# ADDENDUM

Project Name: JHS Renovation  
Tulia I.S.D.  
702 NW 8<sup>th</sup> Street  
Tulia, TX 79088

Addendum No.: **Three (3)**  
Date: April 5, 2010  
Project No.: 09077

SUPPLEMENTAL DRAWING NO. SD-6

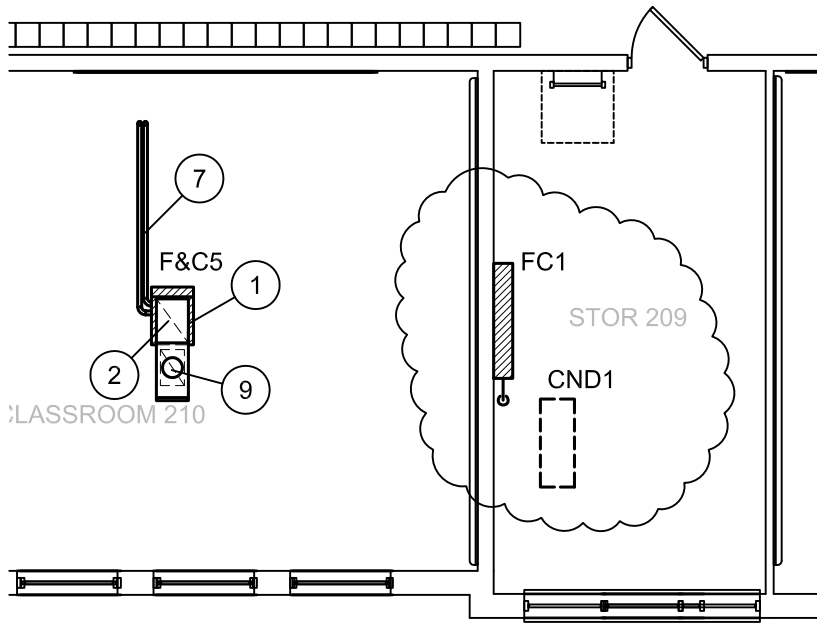
- Item No. Three:** In the Drawings, sheet M2-HVAC PLAN – SECOND FLOOR, Add wall mounted duct free split system at location shown. Mount condensing unit on roof on 4x4 red wood runners covered in single ply roofing material and mount wall unit at location shown as high as possible. Route condensate lines from FC1 down wall through floor to ceiling space below, and connect to condensate drain pipe serving F&C5 as shown on supplemental drawing SD-6 and SD-7 attached herewith.

SUPPLEMENTAL DRAWING NO. SD-8

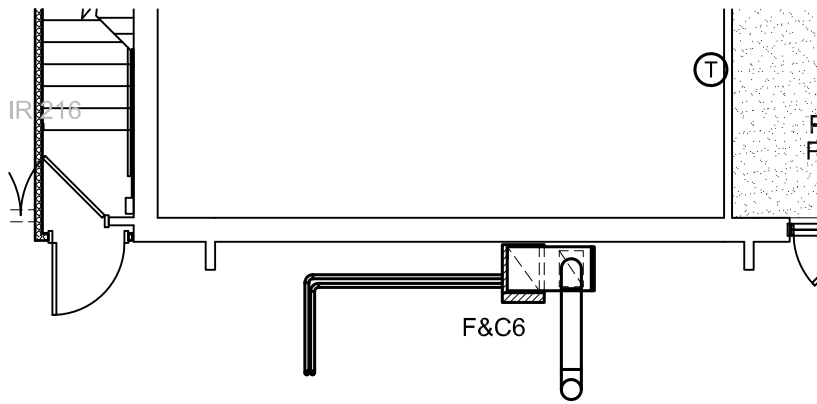
- Item No. Four:** In the Drawings, Sheet E5 – Electrical Schedules and Riser, add circuits to panel DPB (Section 2) to serve CND1 and FC1 as shown on the supplemental drawing SD-8 attached herewith.
